GW - 45

**GENERAL  
CORRESPONDENCE**

**From:** Chavez, Carl J, EMNRD  
**Sent:** Thursday, January 11, 2007 10:46 AM  
**To:** 'Bays, David'  
**Cc:** Price, Wayne, EMNRD  
**Subject:** RE: OCD Discharge Plan Application for Williams Kutz Canyon Gas Plant (GW-045) & Keblah Compressor Station (GW-329)

**Re: Inspection Report**  
**Williams Field Services**  
**GW-045, Kutz Canyon Gas Plant**  
**San Juan County, New Mexico**

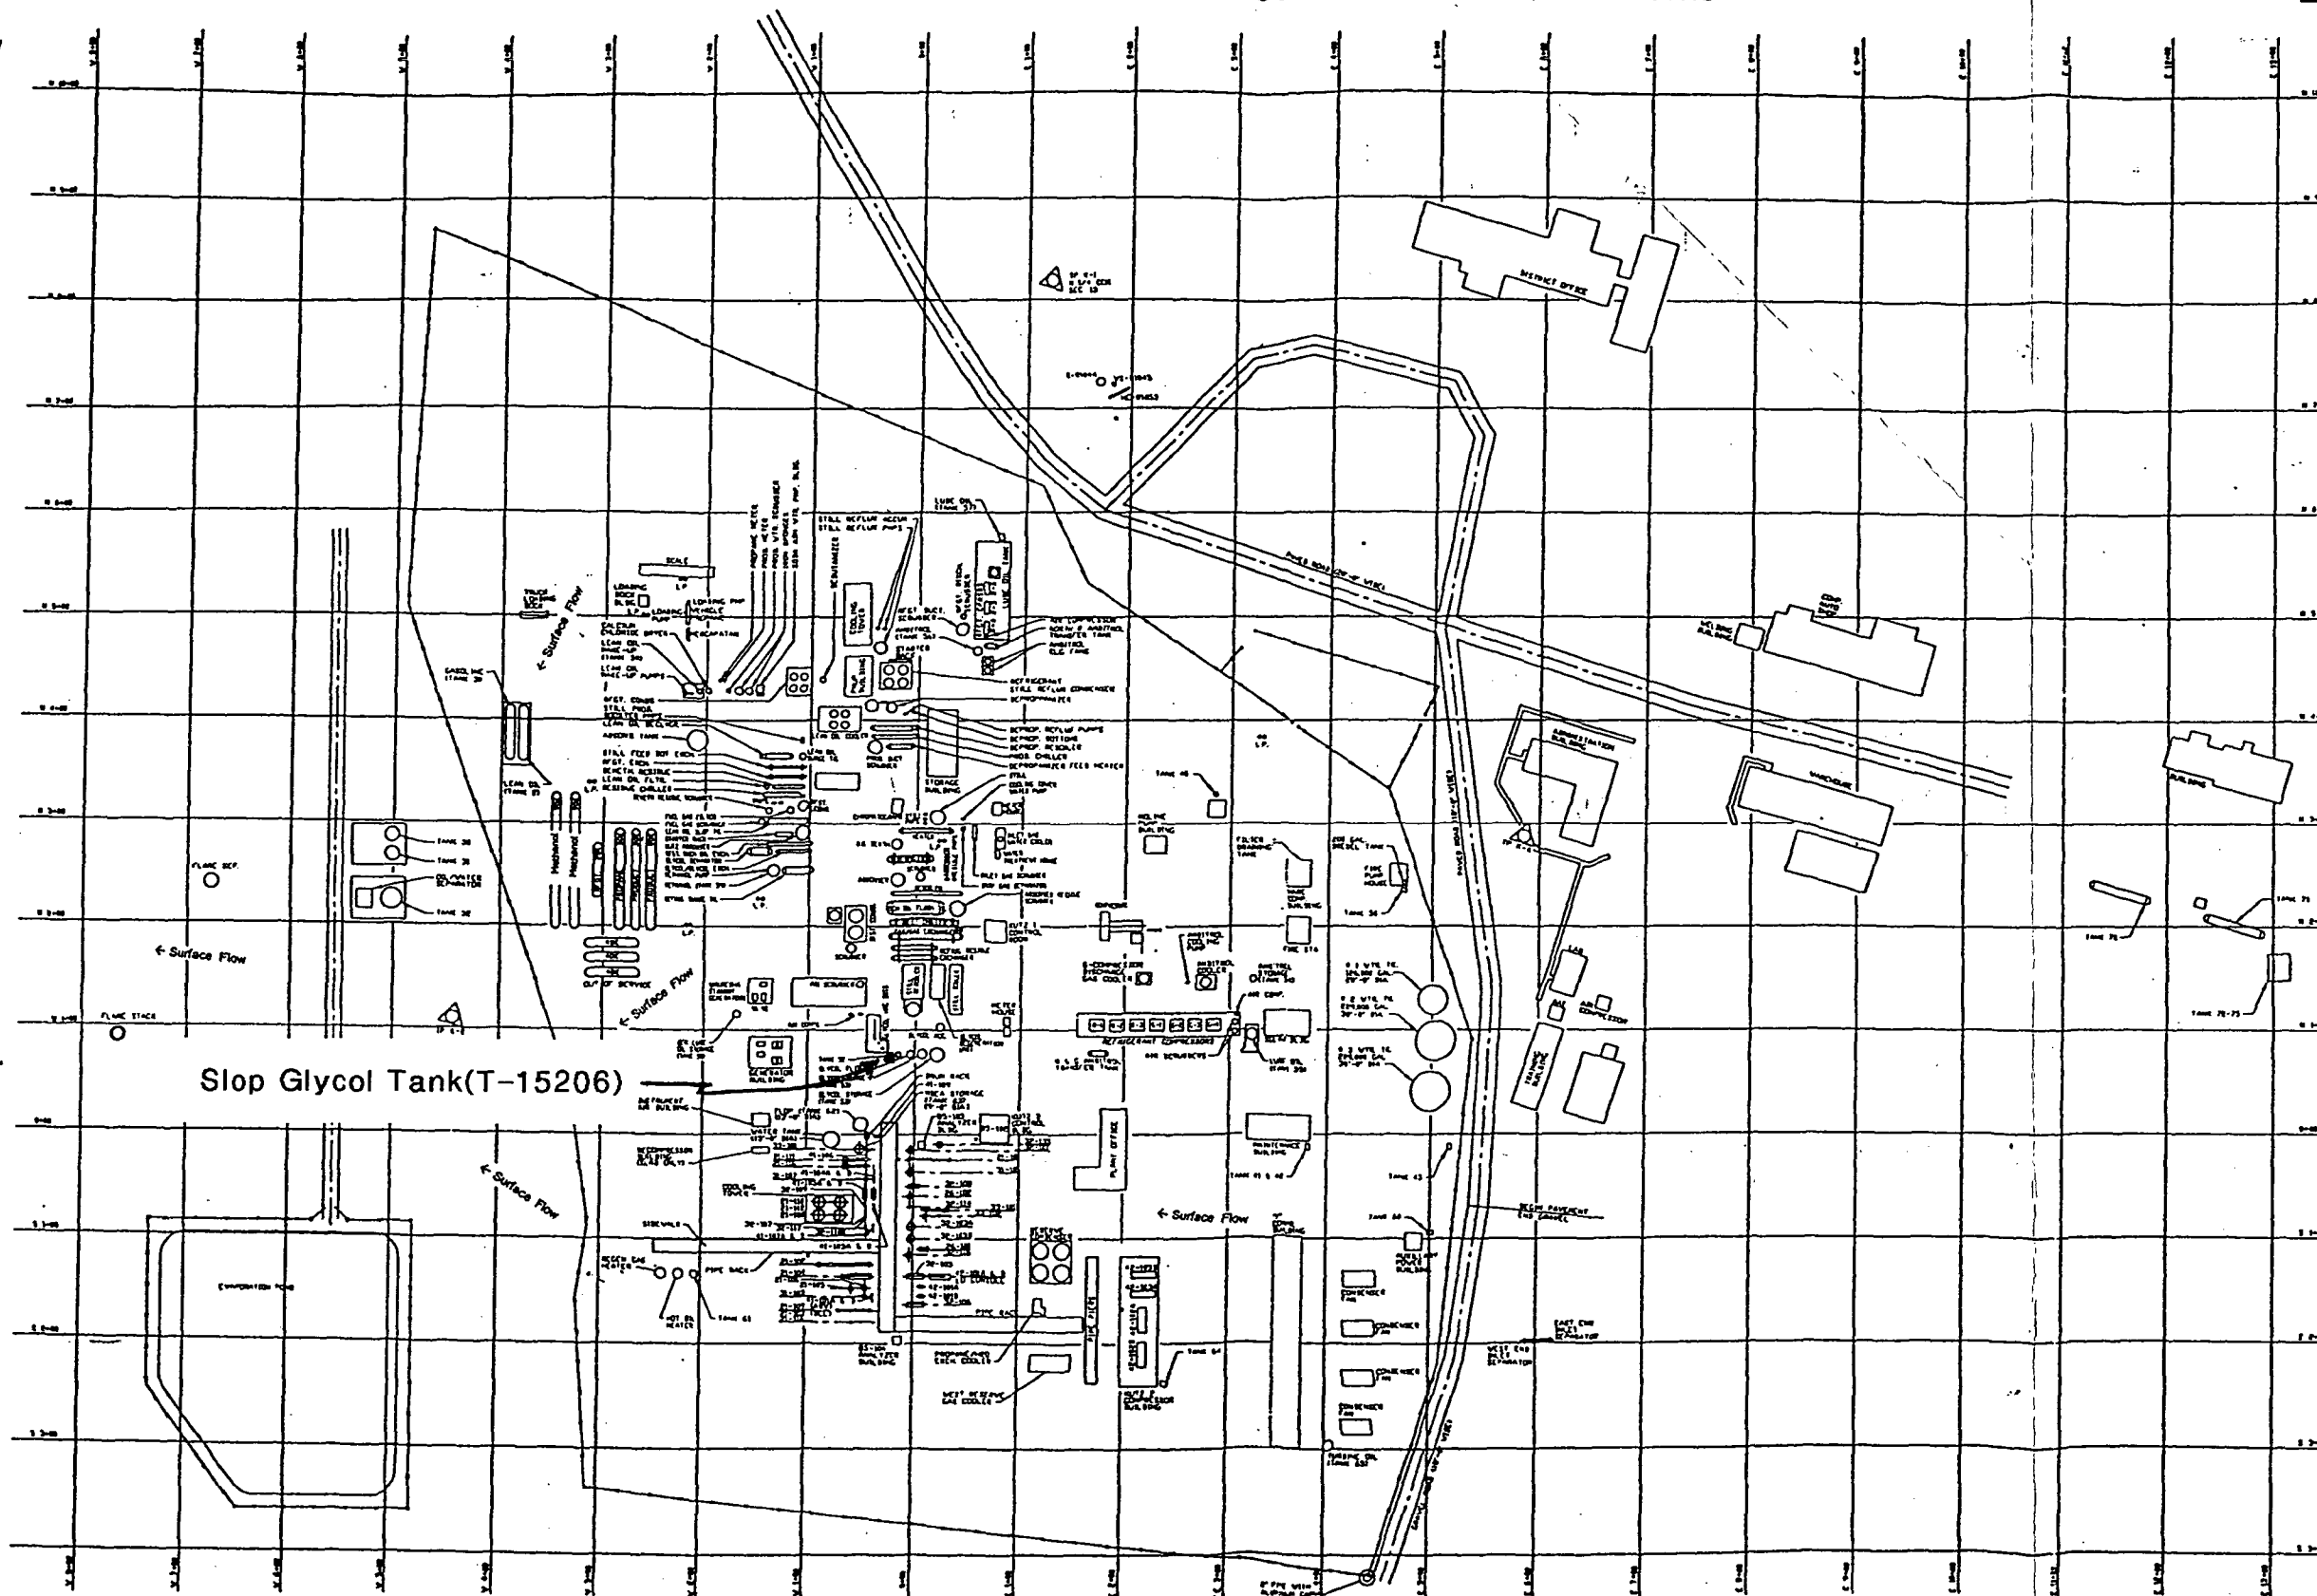
This correspondence is to request permission to locate an additional slop glycol storage tank at the reference facility. The tank will have a 1,000 gallon capacity, located within a block and concrete secondary containment, and will be identified as (T-15206). Refer to the attached Figure (KTZ-1-P7) from the Discharge Plan (February 2003).

Note: Slop glycol tank added July 2003.

Attachment: Kutz Plant Plot Plan  
Xc: Denny Foust, Aztec OCD

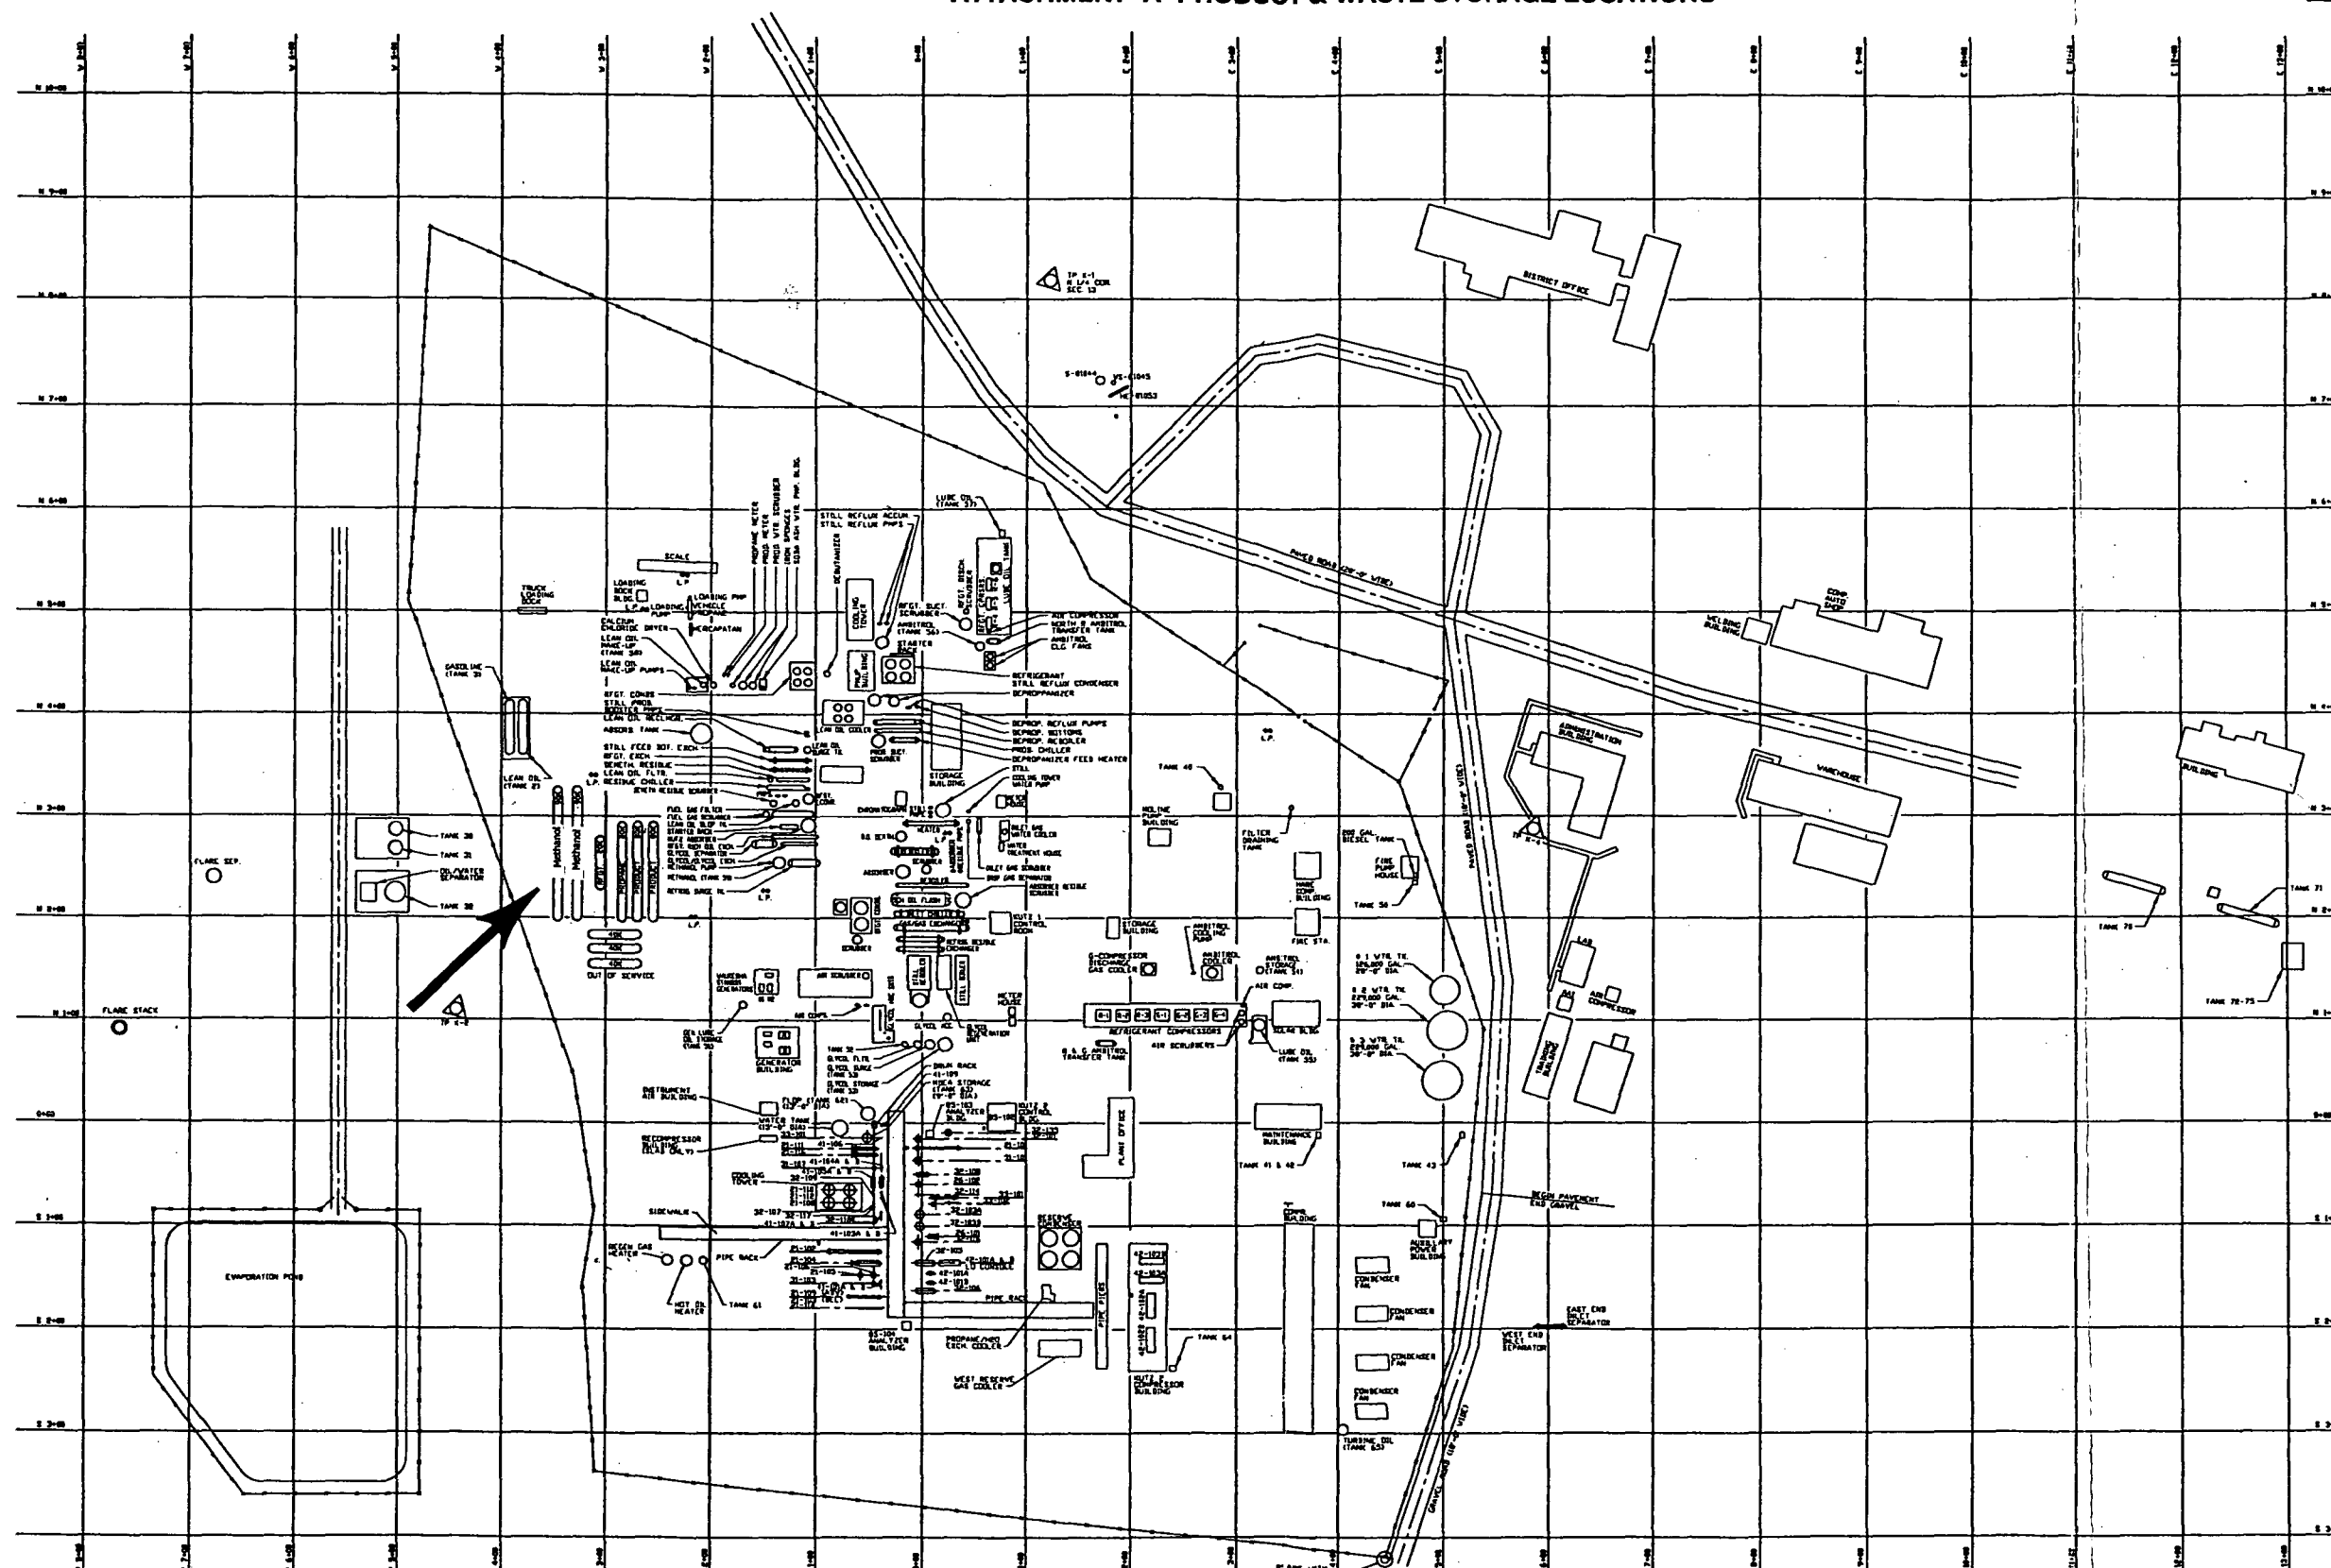
Please be advised that two – 90,000 gallon propane storage tanks are being converted to methanol storage tanks. An impermeable containment will be constructed to contain at least 133% of the tank capacities. The tank locations are highlighted on attached facility plot plan. Please make note of this change in the facility's Discharge Plan.

Photo #1

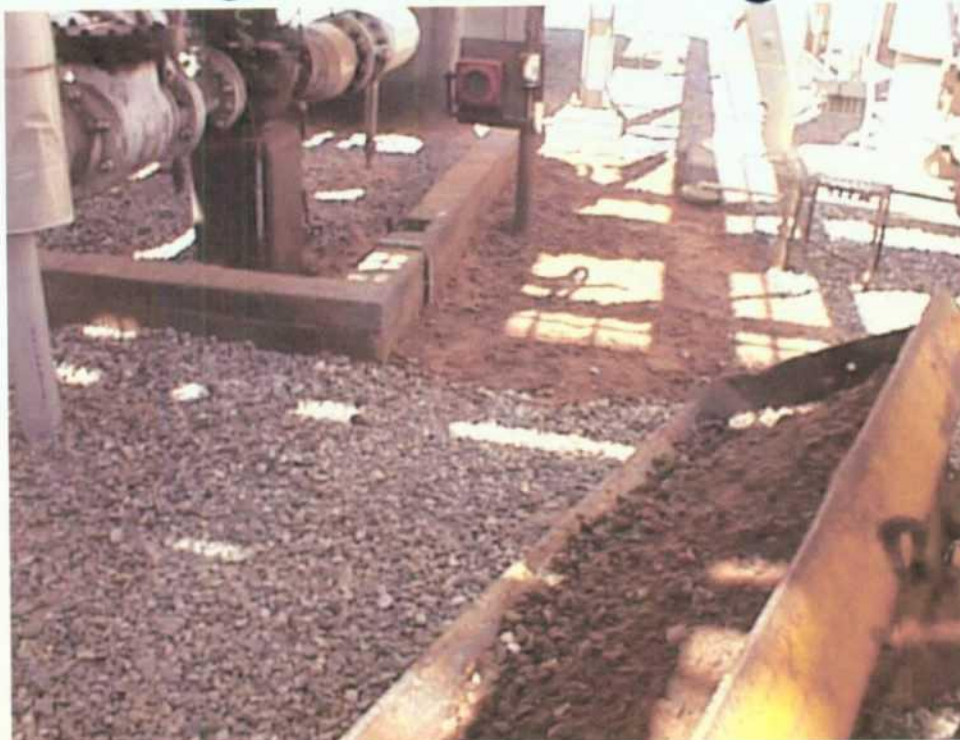
Piping and connection joints show evidence of leaks that have spilled onto the ground surface at Kutz #1 and at the oil/water separator. Some type of collection device should be provided to prevent the spillage onto the ground surface. Evidence of spillage was in the process of cleanup at the time of inspection. (Photos #1 & #2)

GW-045 WILLIAMS FIELD SERVICES KUTZ CANYON GAS PLANT  
Leak/spill onto ground surface at processing area in Kutz #1 part of plant.  
Remediation by excavating contaminated soils.  
July 7, 1999

Photo #3

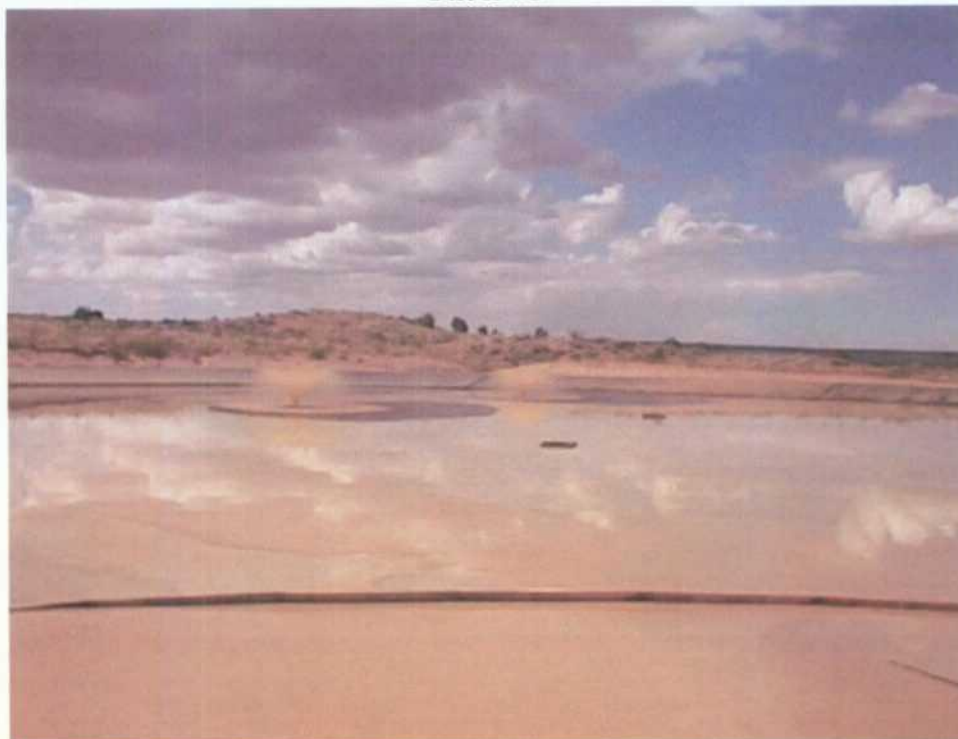
GW-045 WILLIAMS FIELD SERVICES KUTZ CANYON GAS PLANT  
Oil emulsion on surface of evaporation pond  
July 7, 1999

GW-045 WILLIAMS FIELD SERVICES KUTZ CANYON GAS PLANT  
Oil emulsion on surface of evaporation pond  
July 7, 1999

Photo #5

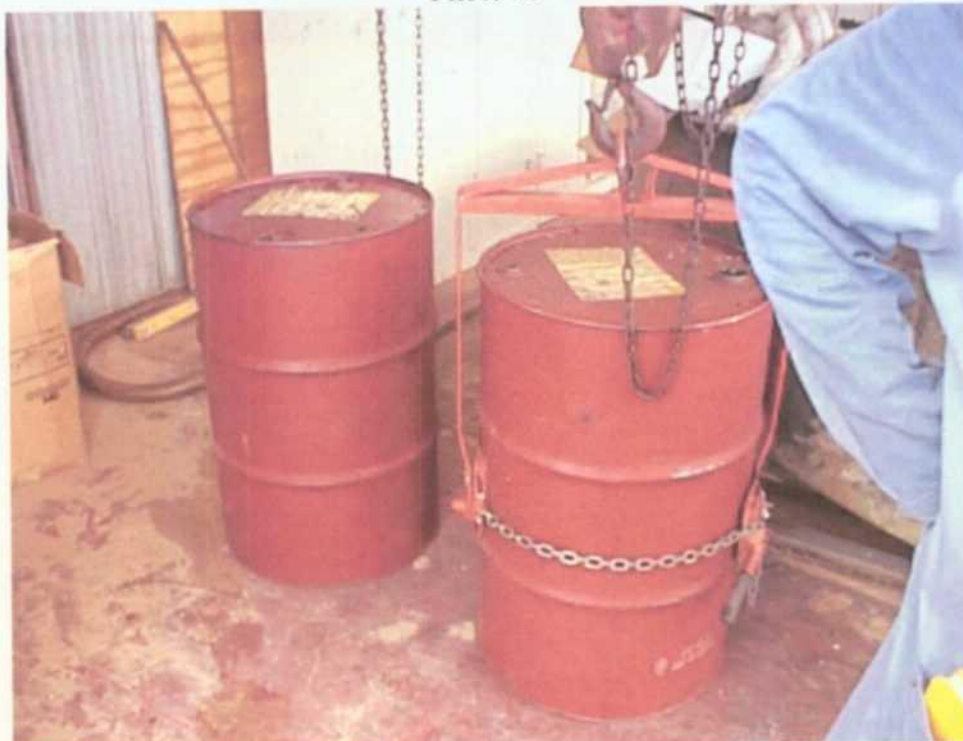
Drums containing fluids were were not properly stored in the building containing the absorbent sock and pad collection tank. Drums were not properly labeled. Plant personnel need to be instructed on the proper storage of empty drums. (Photo #5)

GW-045 WILLIAMS FIELD SERVICES KUTZ CANYON GAS PLANT  
Improperly stored drums  
July 7, 1999
